## CHAPTER 3 – REVISIONS, CLARIFICATIONS, AND CORRECTIONS TO THE DRAFT EIR

Harvard-Westlake River Park Project

**Figure II-11**  
Gymnasium Level 2

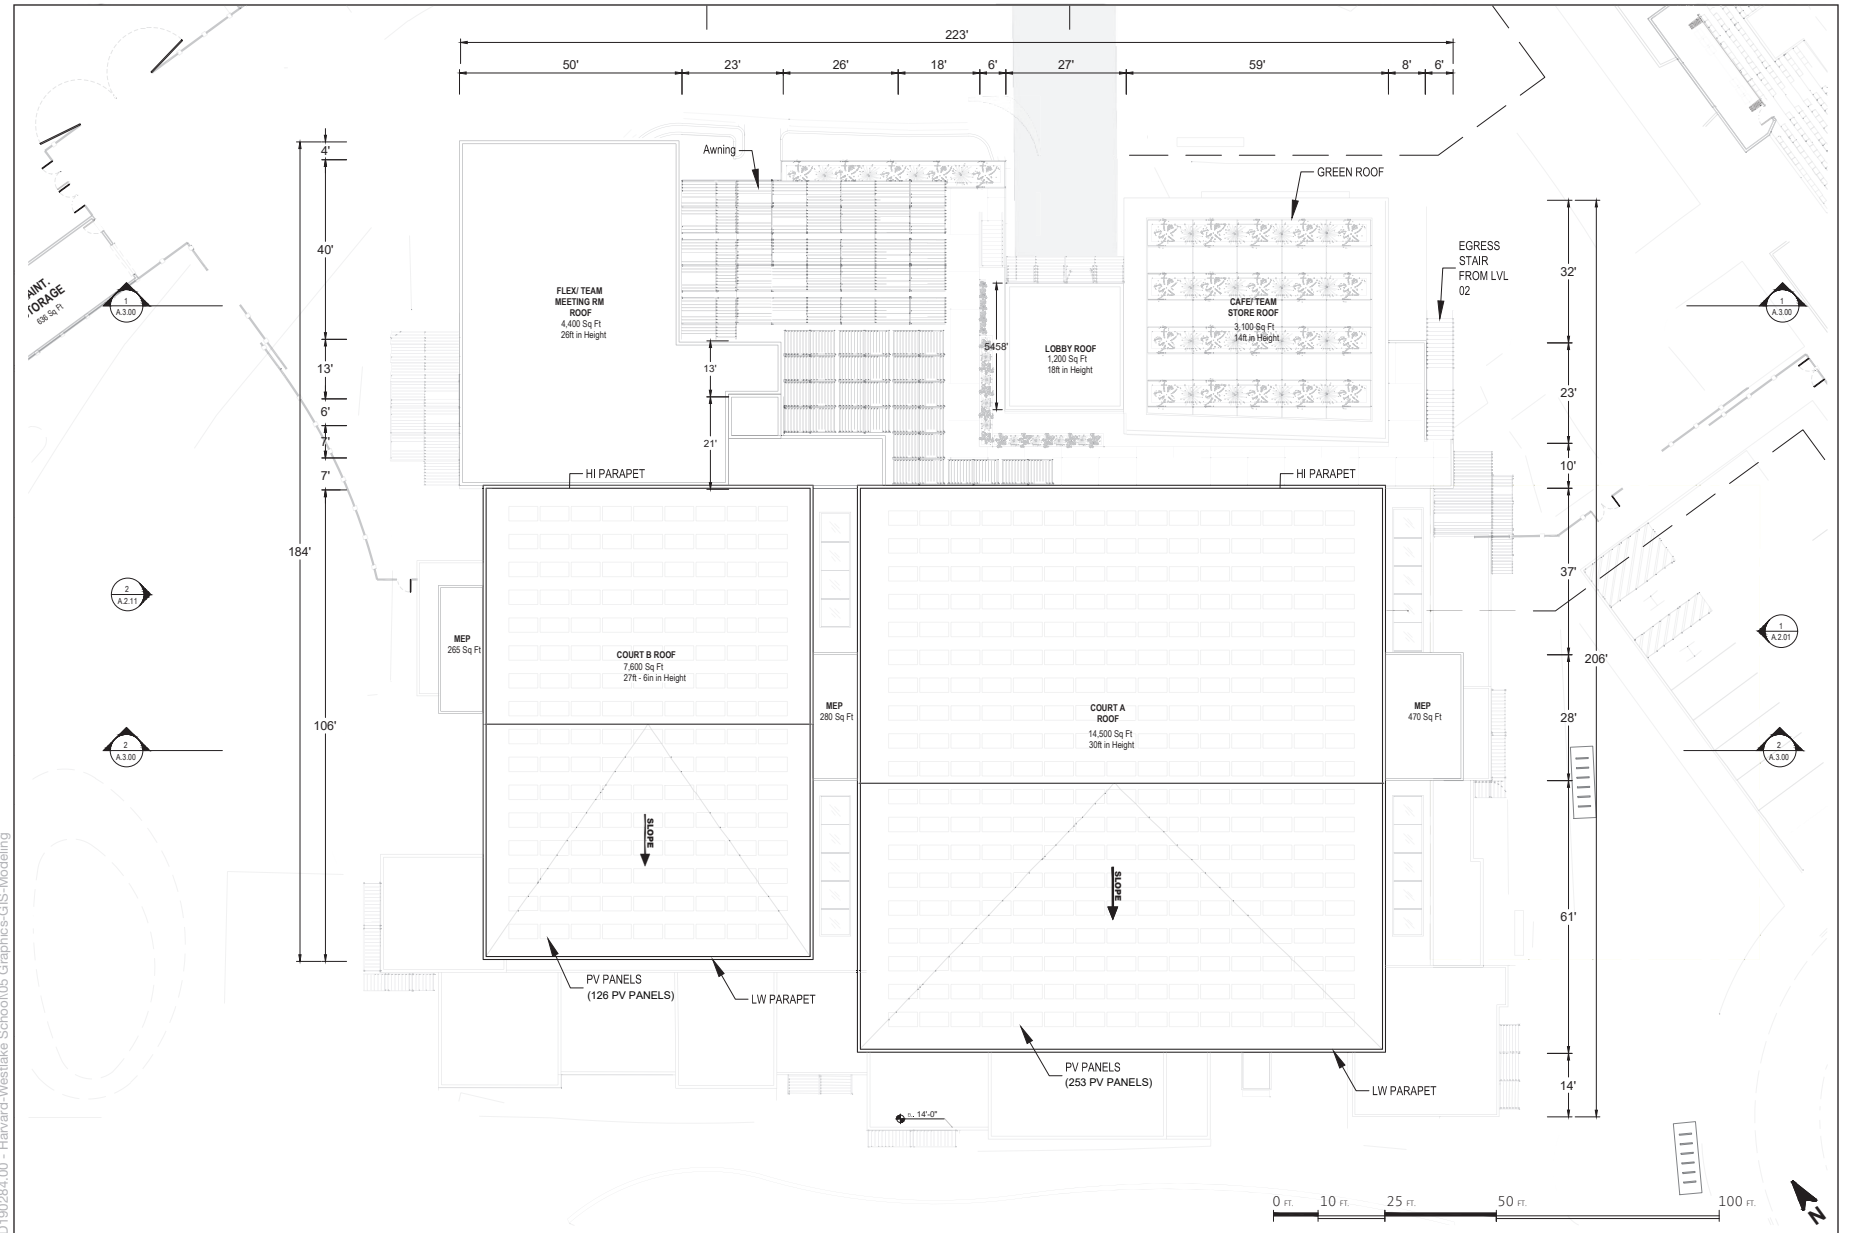
17. Page II-24, Figure II-11, *Gymnasium Level 2*, is updated to show the removal of outdoor lights along Field A and the reduced footprint of the parking structure adjacent to the gymnasium building.

**Figure II-12**  
Gymnasium – Roof Plan

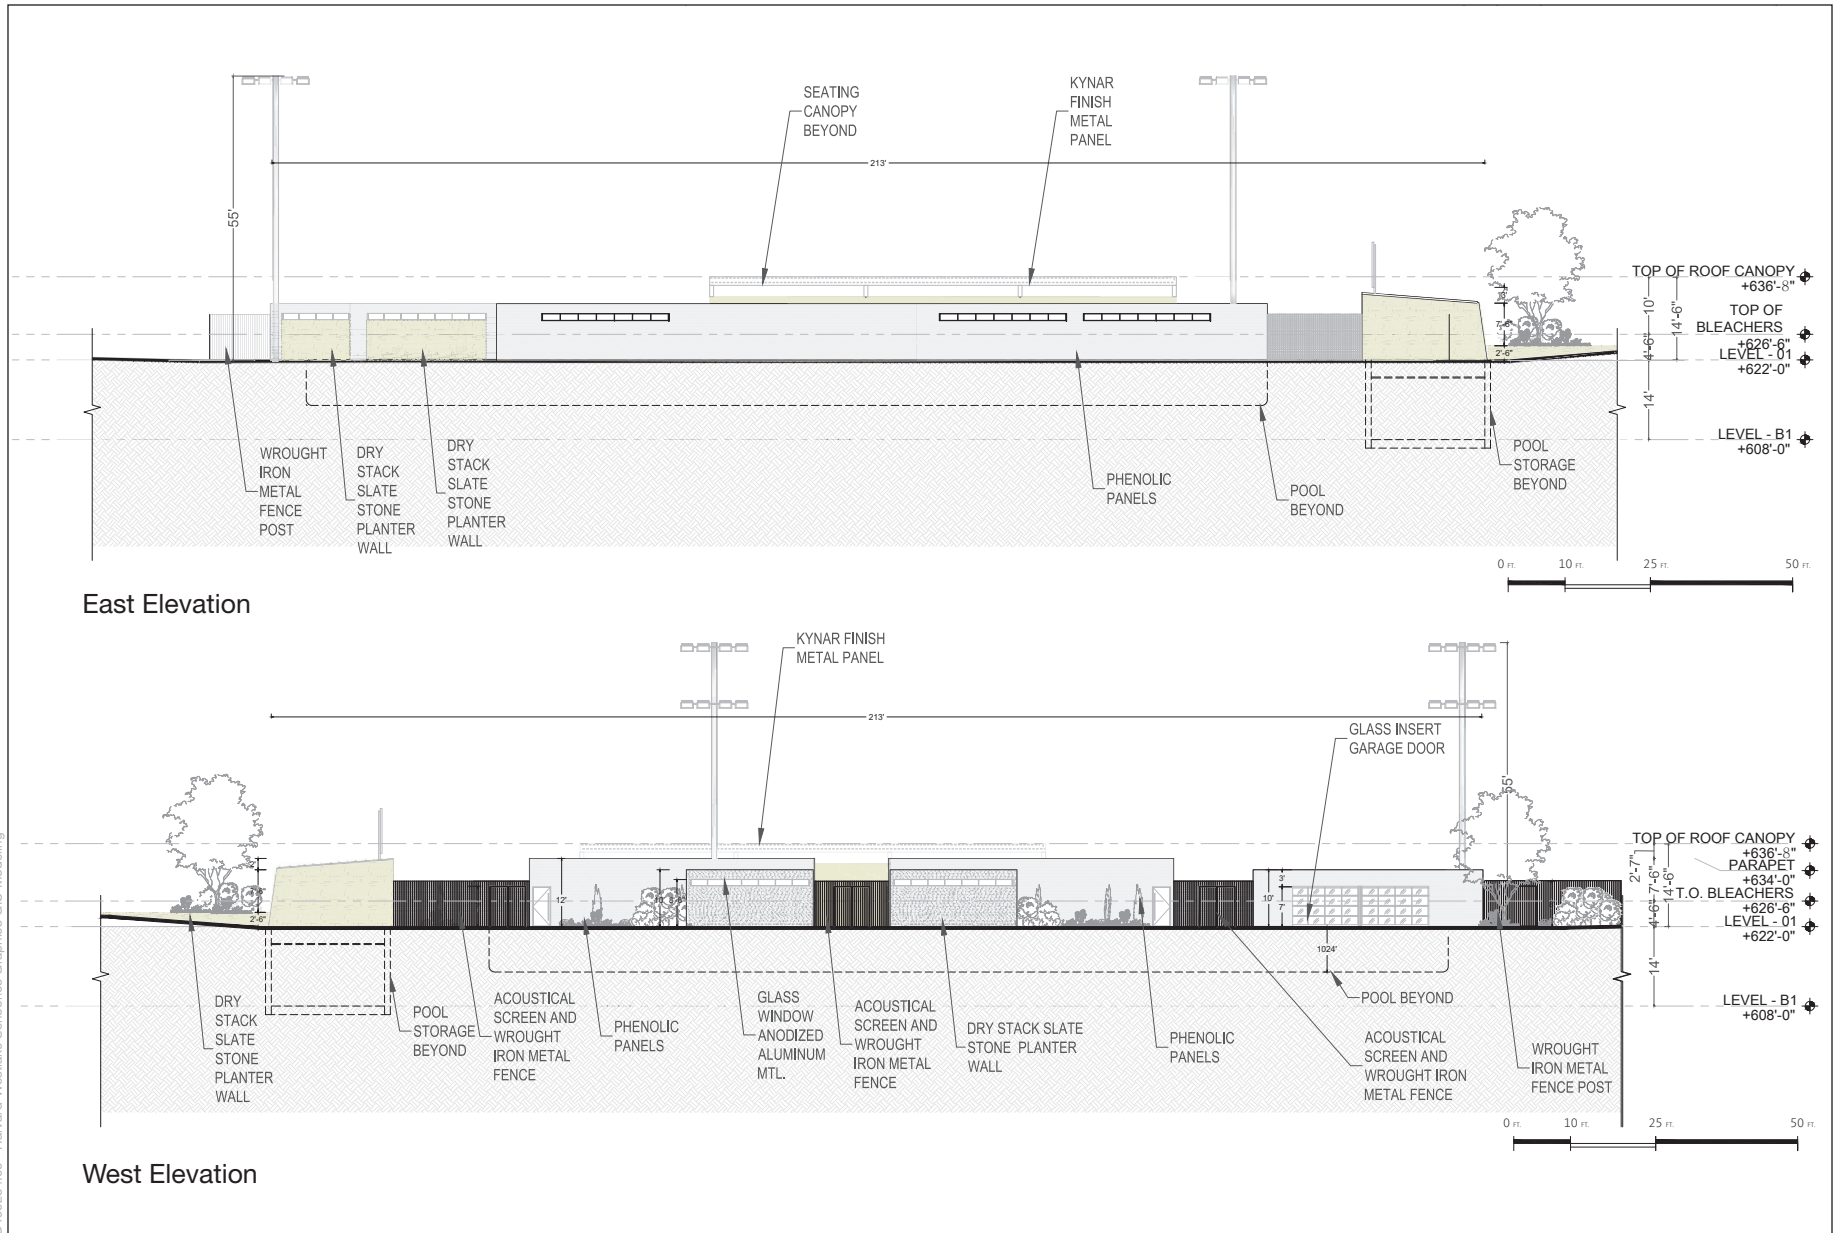
18. Page II-25, Figure II-12, *Gymnasium – Roof Plan*, is updated to show the removal of outdoor lights along Field A, revision to the number of solar panels on the gymnasium roof, and the reduced footprint of the parking structure adjacent to the gymnasium building.

**Figure II-15**  
Valley Spring Lane Elevations

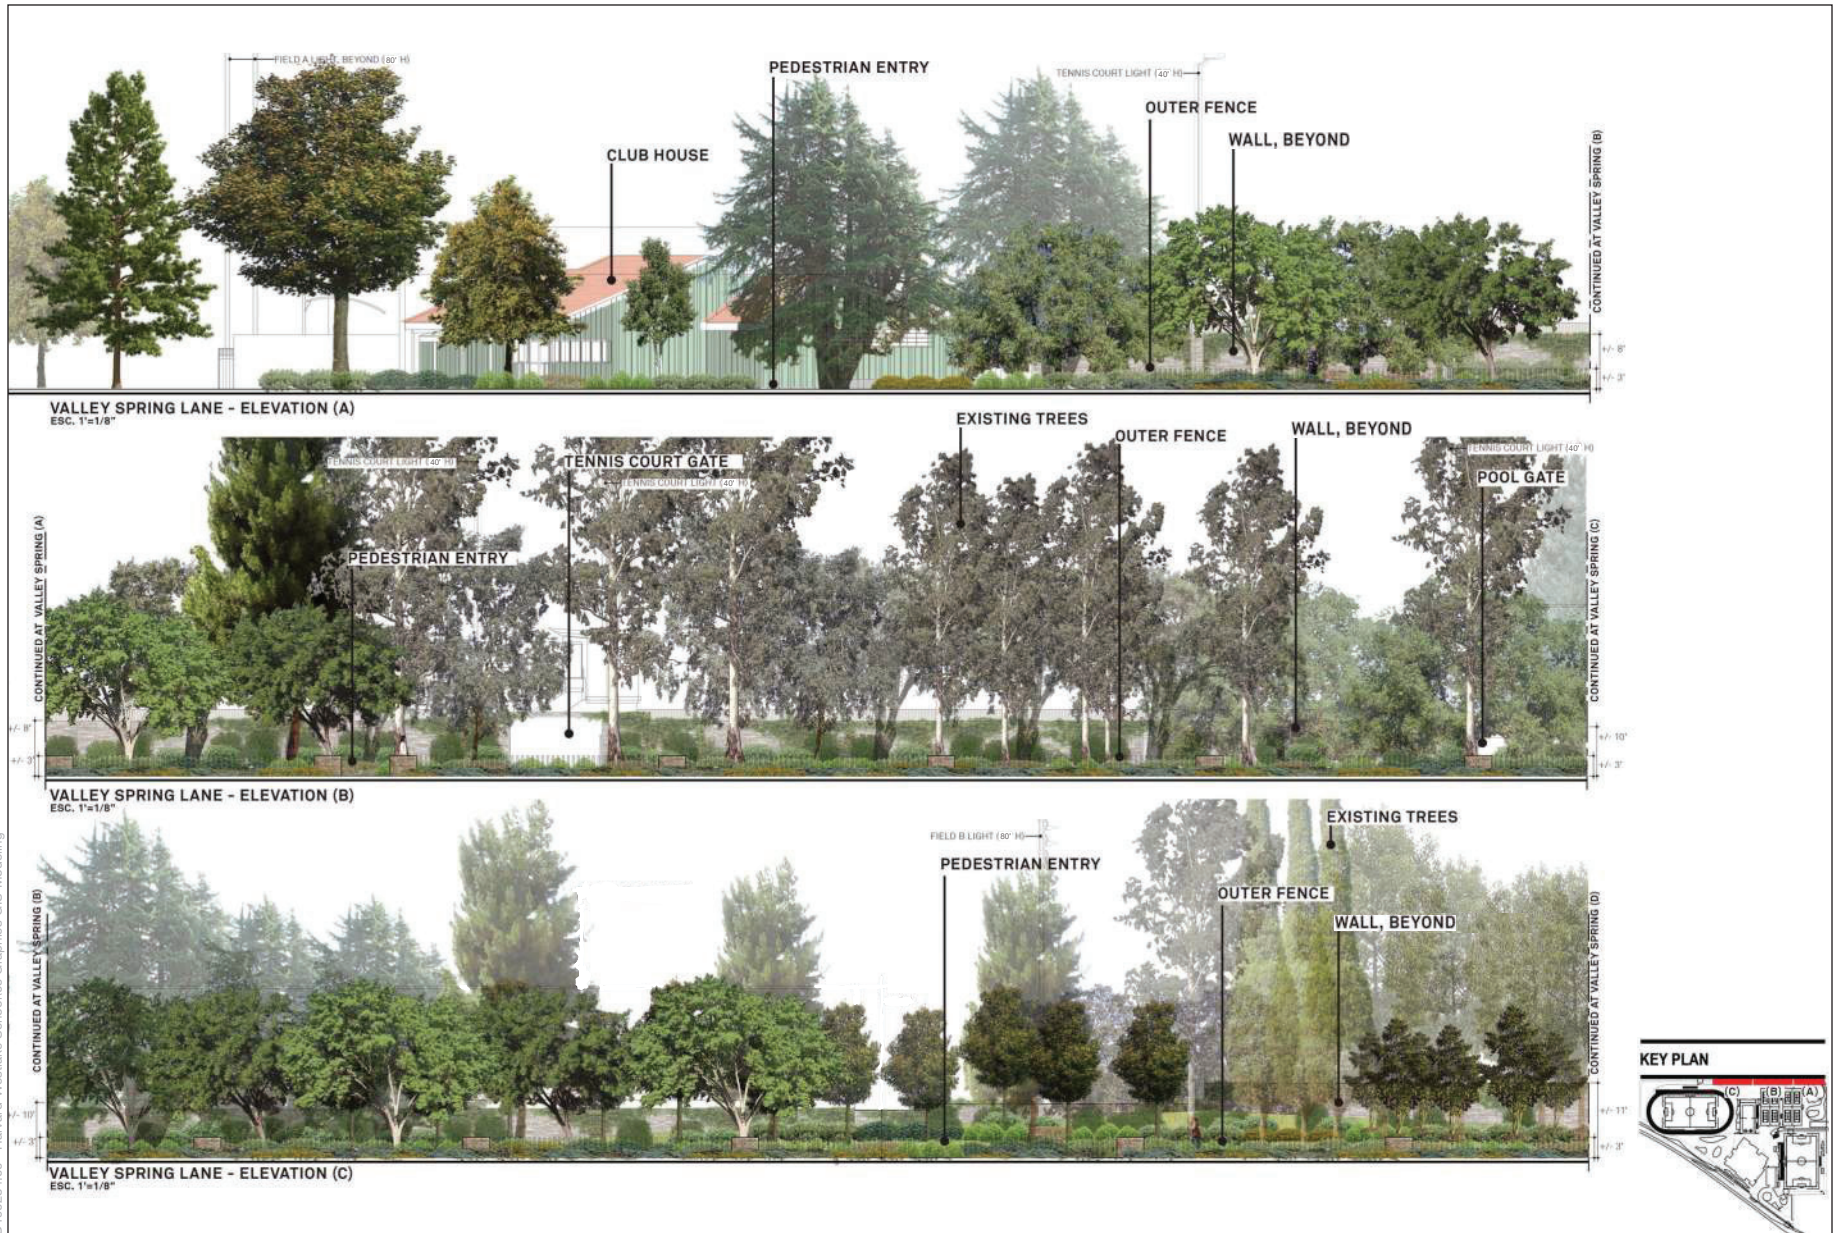
24. Page II-36, Figure II-15, *Valley Spring Lane Elevations*, is updated to show the increase in the height of the Field A and B light poles to 80 feet and reduction in the height of tennis court light poles to 40 feet. The pool canopy, lower in height and reduced in size, is no longer visible in this view.

**Figure II-17**  
Whitsett Avenue Elevations

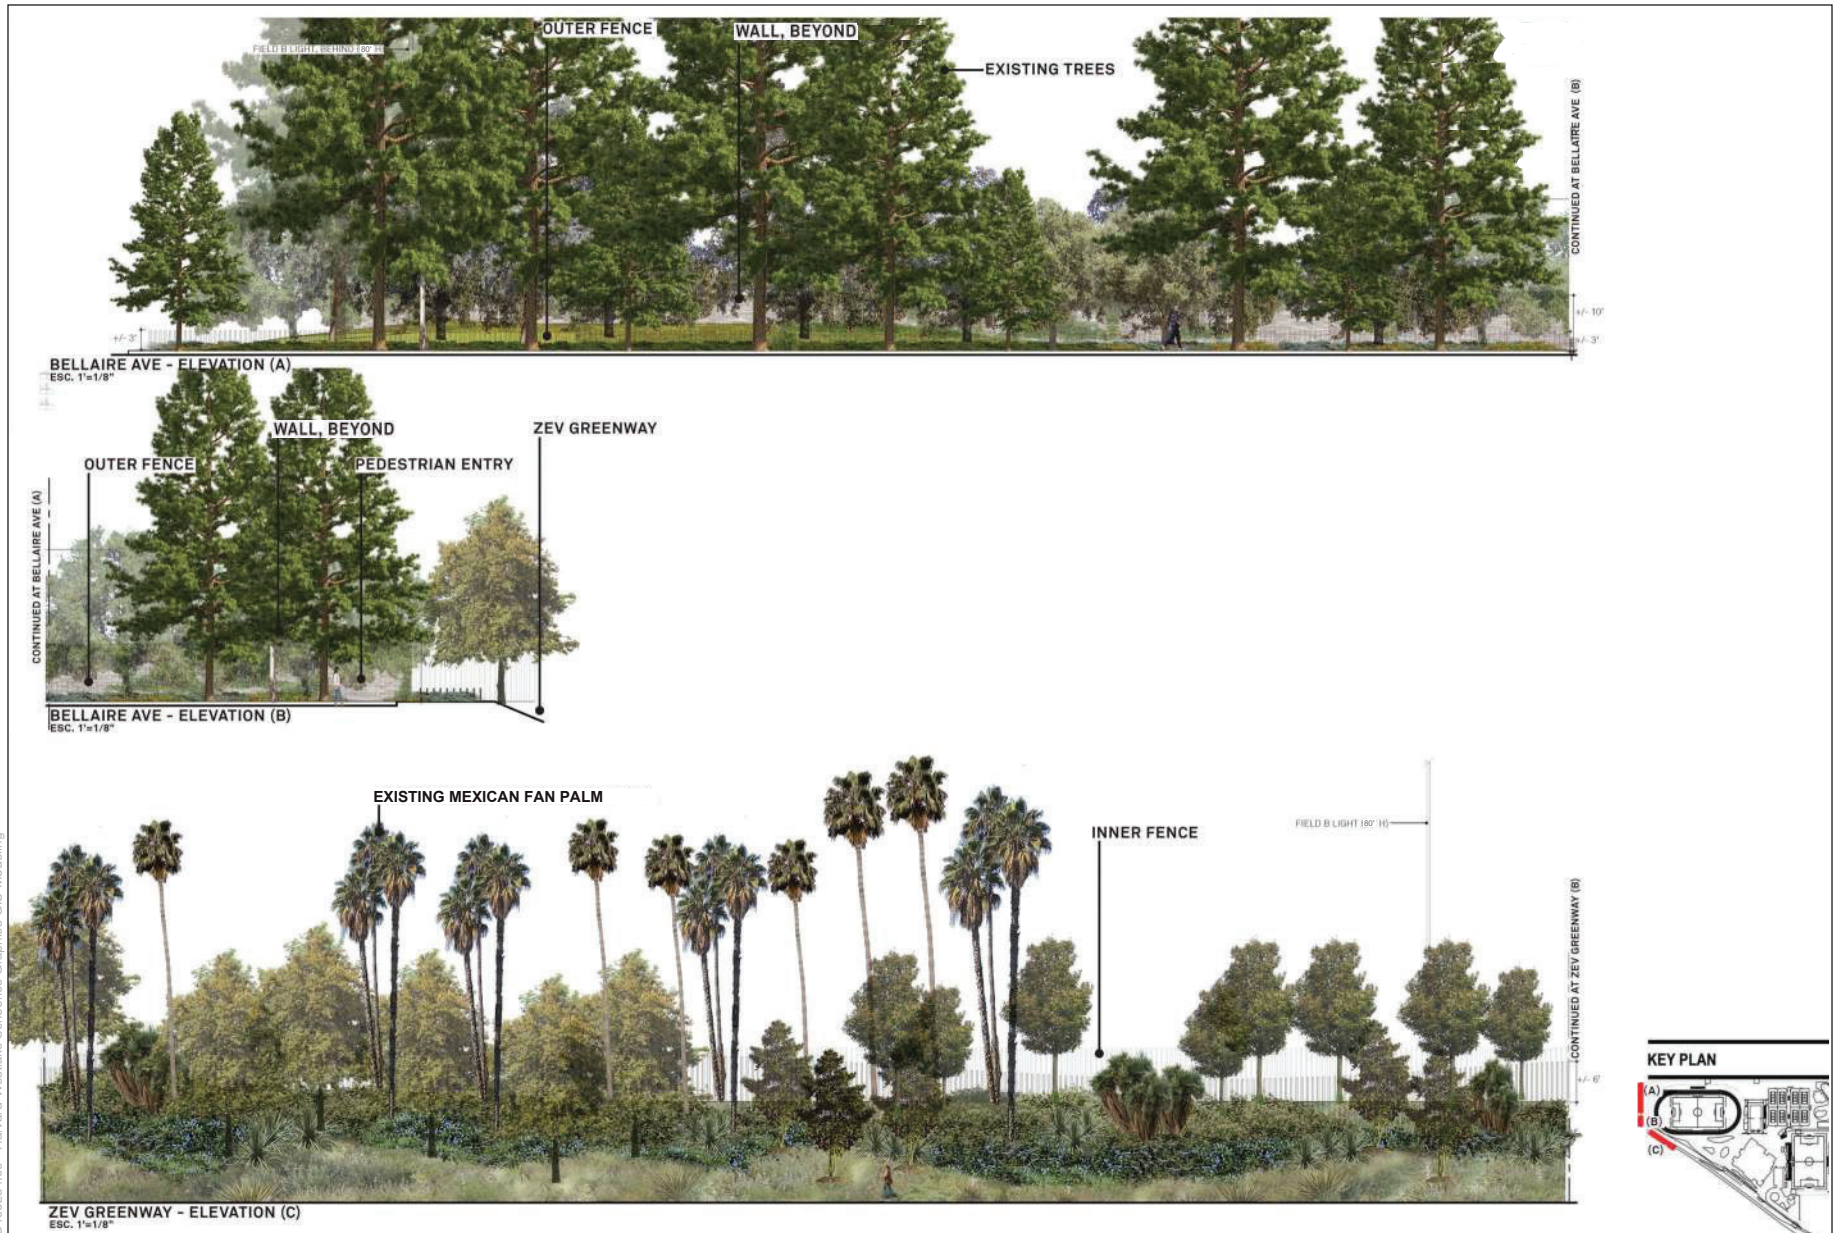
26. Page II-38, Figure II-17, *Whitsett Avenue Elevations*, is updated to show the removal of a visible field light pole in Elevation (B), reduction in visible tennis court light poles to 40 feet, and the increase in heights of Field A light poles to 80 feet.
